## Design Review Subcommittee (DRSC)

Meeting Date: May 24, 2017

**SUBJECT:** **Cultural Heritage Permit 17-094 / Minor Exception Permit 17-095, Webber Residence 2**, a request to consider the construction of a single-family residence at 161 Calle Redondel in the Residential Low Zone and Coastal Zone Overlay (RL-CZ).

**Exhibit 1: Orientation of Adjacent Lots**

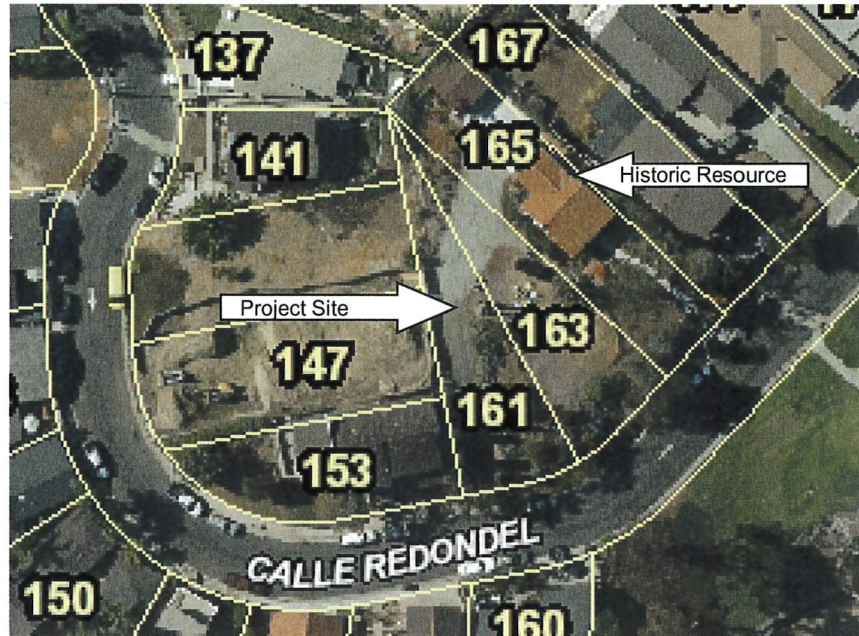
Because the project site shares one property corner at the back of the lot with the lot containing the historic resource at 165 Calle Redondel, the zoning code defines the two sites as "abutting" and a CHP is required. The proposed structure will not be directly adjacent to the historic structure and staff does not foresee that this project will have the same potential impacts on the historic site as the project at 163 Calle Redondel. The goal of the CHP is to review and condition the proposed structure to reduce impacts to the historic resource to the greatest extent possible.

The exhibit below shows the location and orientation of the project site, relative to the adjacent lots and the historic resource.
